Entergy Operations, Inc.
1448 S.R. 333
Russellville, AR 72801
Tel 501 858-5000

1CAN020007

Subject: Arkansas Nuclear One - Unit 1
Docket No. 50-313
License No. DPR-51
Supplemental Information for Alternative Code Repair of Hot Leg Nozzle RC-1071/1072

FIGURE 9-1
FINITE ELEMENT MODEL OF REPAIR DESIGN

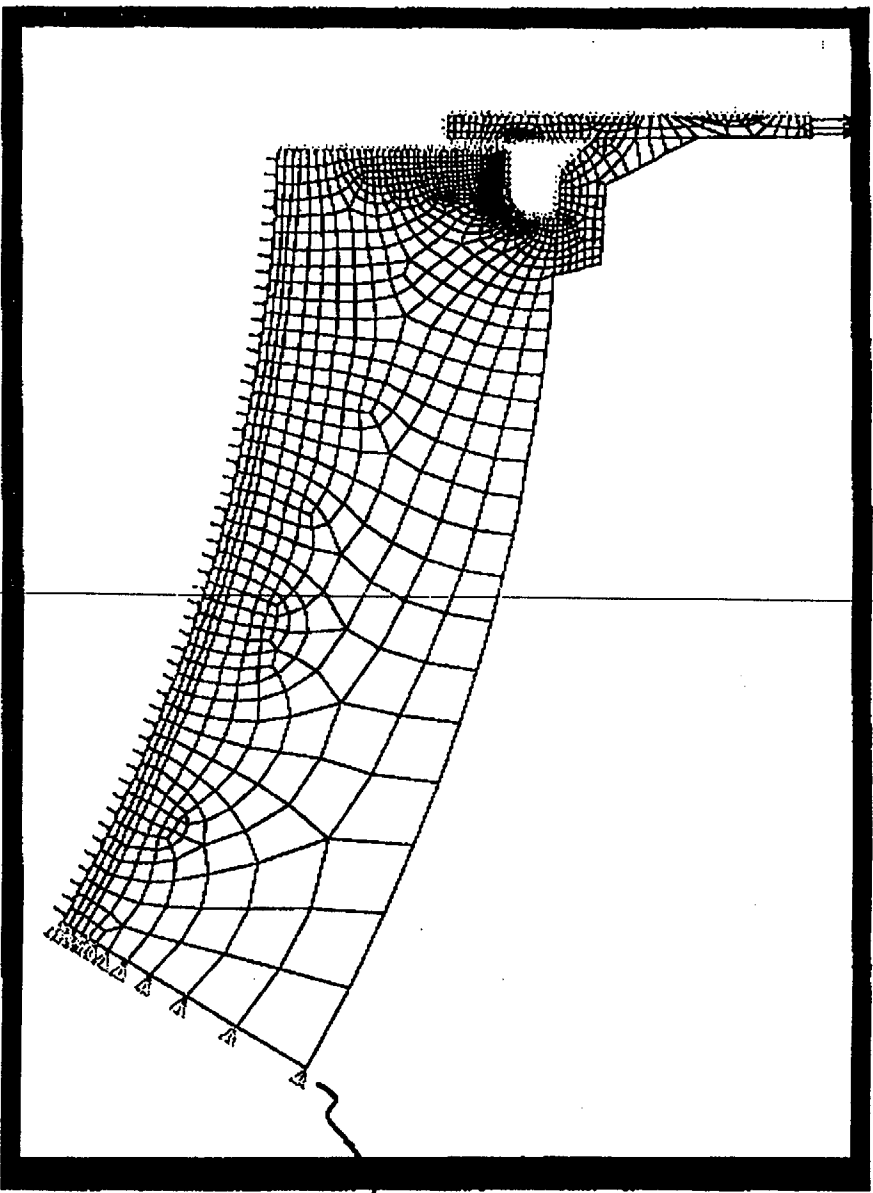
NRC Question 4: Provide summary details of the analysis performed for the weld pad overlay for the subject Code alternative repair.

ANO Response: Enclosure 2 is a letter from Framatome Technologies dated February 24, 2000 (FTI-00-512) that provides a summary of the weld pad overlay repair. This also includes two diagrams showing the mesh of the finite element model.

- The analysis of the repair design for Primary Stresses includes the following features –
- a) The structural analysis is performed using the finite element method (using the ANSYS FE program)

- b) An axisymmetric analytical model is employed – including Hot Leg Pipe, cladding, nozzle, original J-groove/fillet configuration and the repair weld pad/fillet welds

- c) The Hot Leg Pipe is modeled as a spherical segment with adjusted (increased) pressure to conservatively simulate the stress levels in the Hot Leg elbow

- d) The pressure is applied to all internal surfaces including the perimeter of the original welds (i.e., effectively the original welds are considered as non-existent or void)

- e) No structural strength is credited to the original J-groove/fillet welds
 - f) Both the run pipe (Hot Leg elbow) moments and branch pipe (Level Tap Nozzle) loads are conservatively applied to the FE model in conjunction with the internal pressure

FIGURE 7-1
 GEOMETRY OF NOZZLE REPAIR

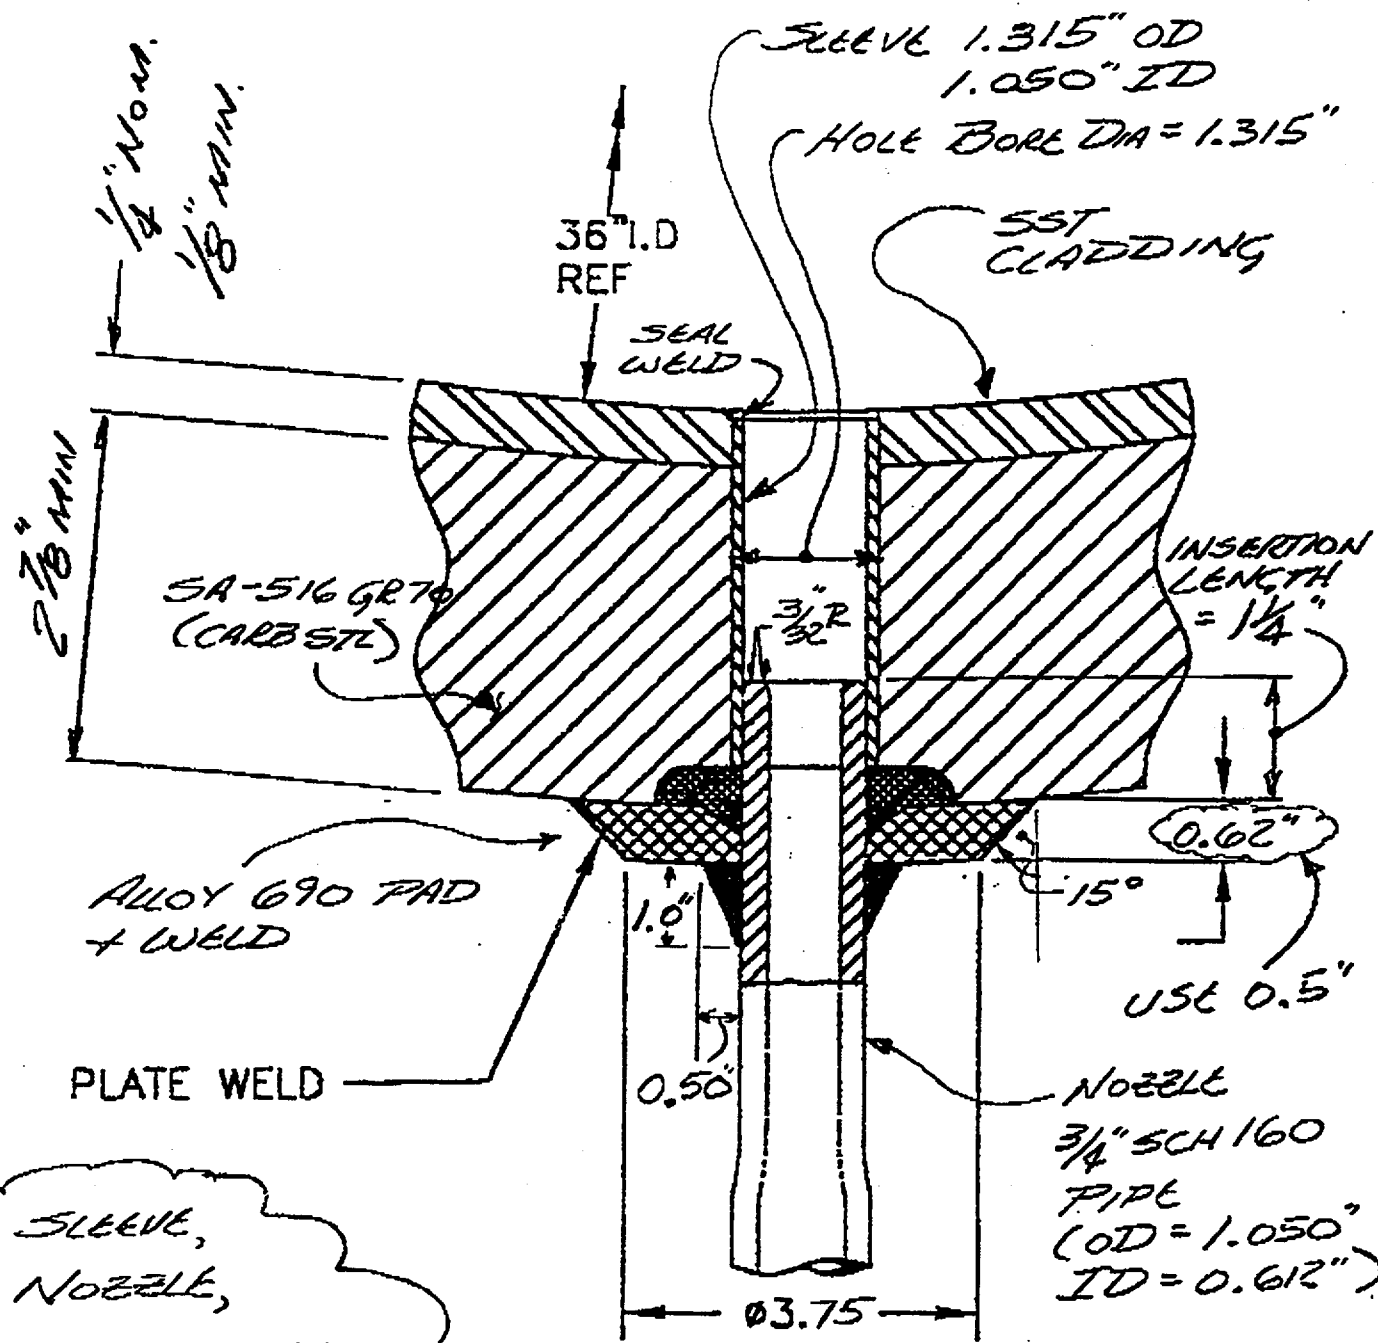
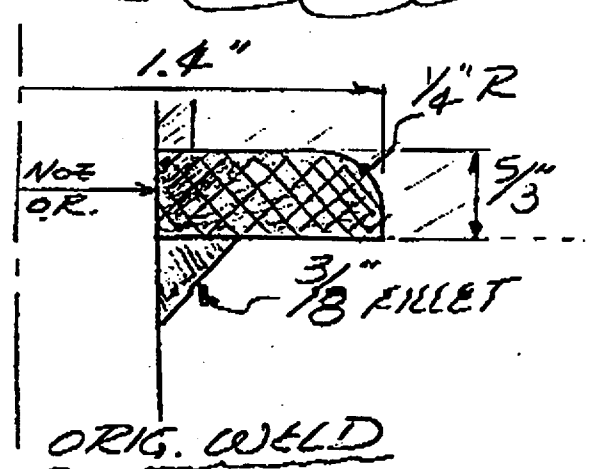
NRC Question 5: Provide sketches and qualitative discussion of the assumed flaws that were used for interaction with the base metal and for the new weld pad repair.

ANO Response: Enclosure 3 provides four diagrams and descriptions of the flaws assumed in the analysis for the hot leg base metal and the new weld pad overlay.

ALLOY 690 PAD
 + WELD
 PLATE WELD

SLEEVE,
 NOZZLE,
 ORIGINAL WELD
 ARE ALLOY 600
